APPLICATION FOR PERMIT TO DRILL, DEEPEN, OR PLUG BACK

2. NAME OF OPERATOR  
 Samedan Oil Corporation

8. FARM OR LEASE NAME  
 Laguna Federal

Re: Amendment to APD  
Laguna Federal #1

# PROPOSED ROUTE

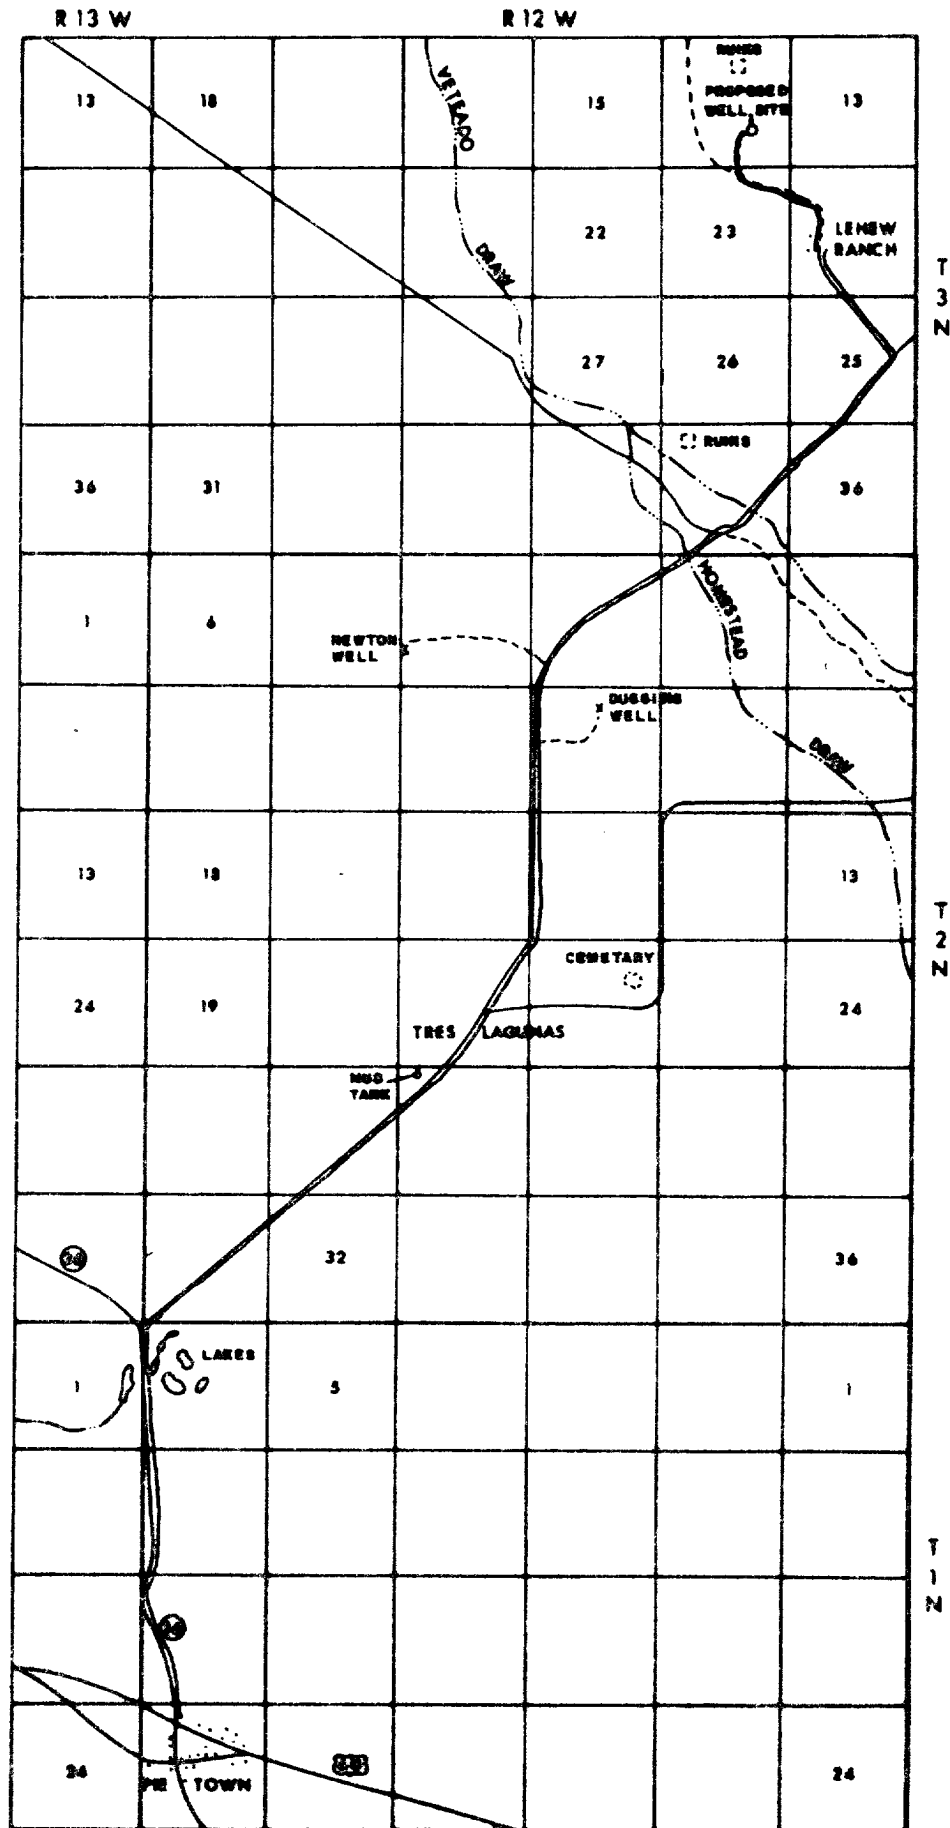
The proposed new access road, which follows an existing trail from the Lebew Ranch to the well, will be changed to bypass an archeological site. The site is located in the existing trail 1550' FNL and 100' FEL in Section 23, T3N-R12W. The access road will be moved 120' southwest of the existing road to avoid the archeological site.

Two proposed 24" culverts for the proposed new access road will not be used. The access road will make a dry crossing through the two drainage areas.

EXHIBIT #4  
DRILLING PAD

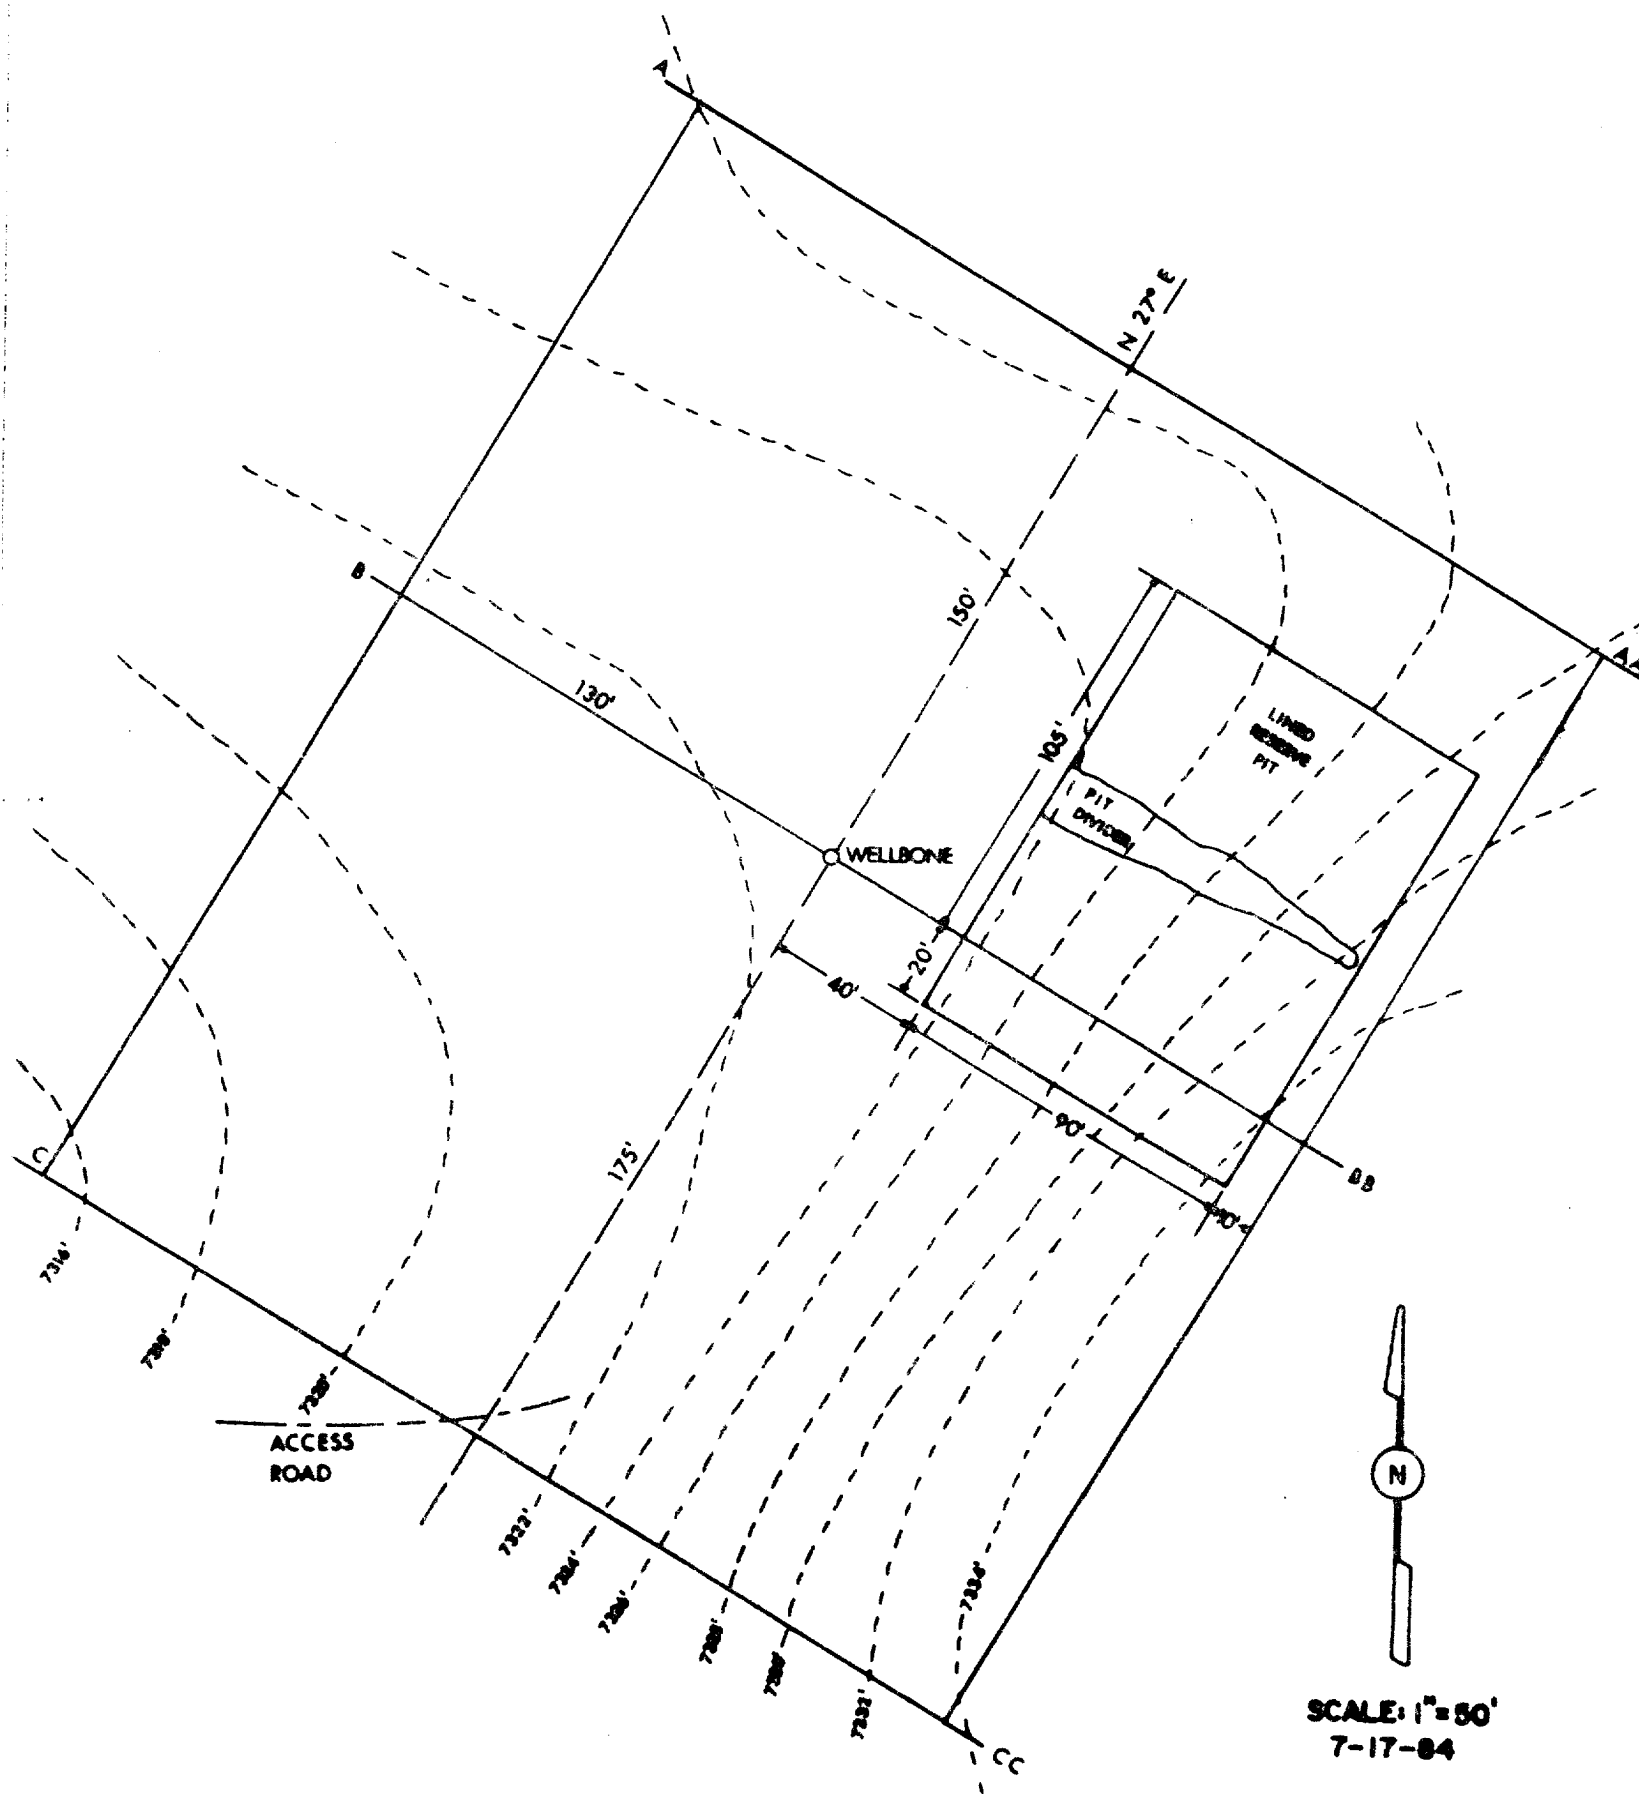
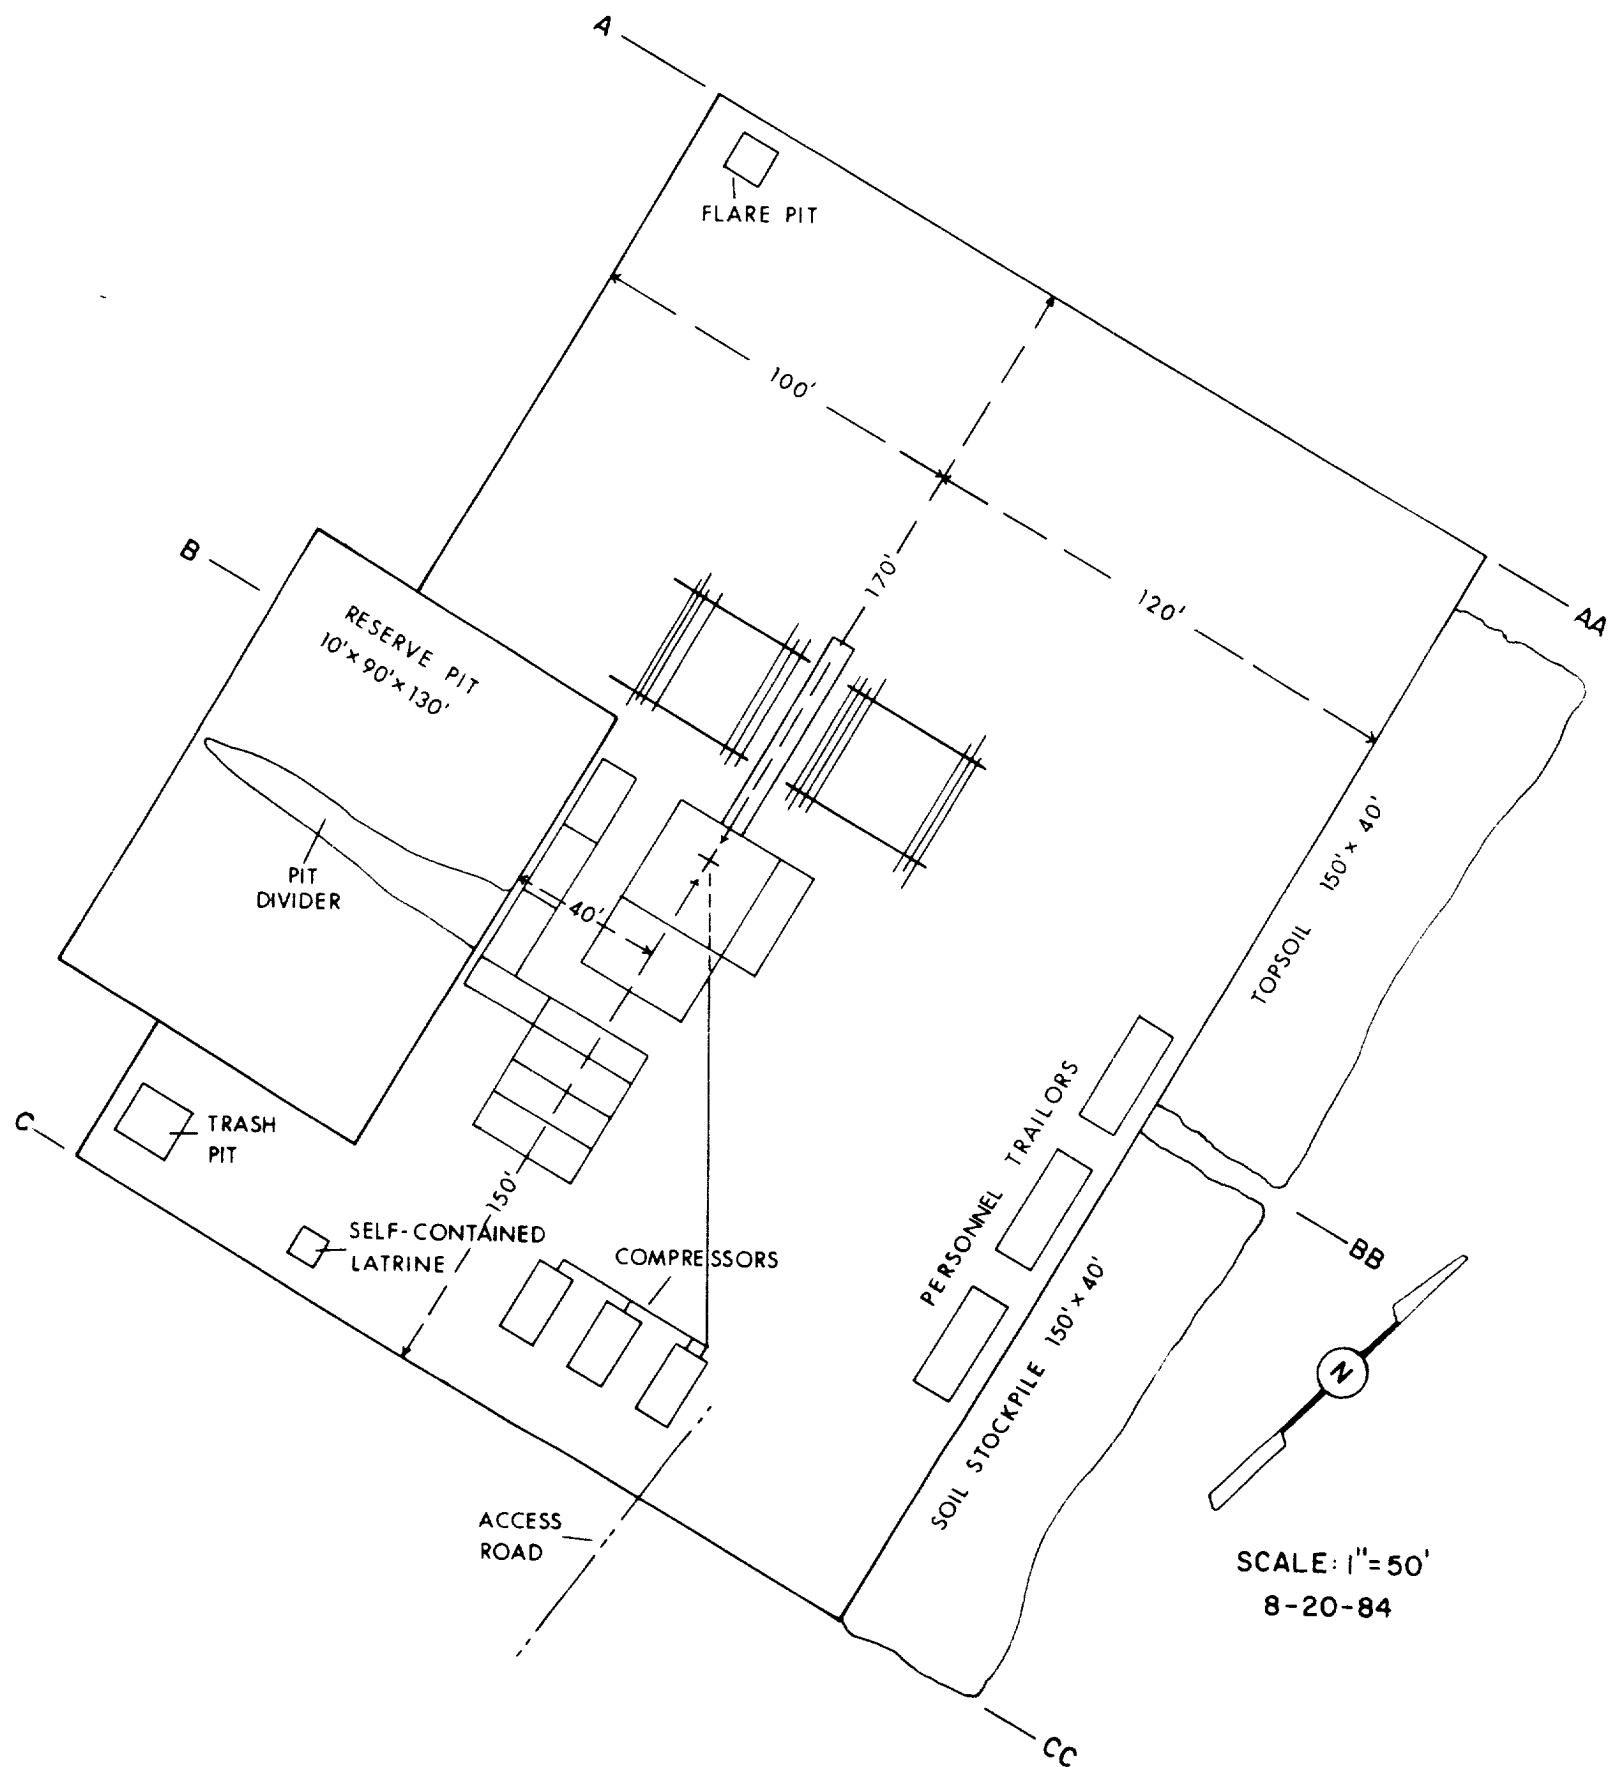
Exhibit 4 showing the drilling pad layout has been changed. The new layout is slightly smaller. The orientation has been changed to place the entire pit in a slight fill area. This will reduce the amount of dirt work required. The topsoil and subsoil stockpiles have been moved to the east side of the location. This reduces the amount of activity near the archeological site LAC-8447a-1.
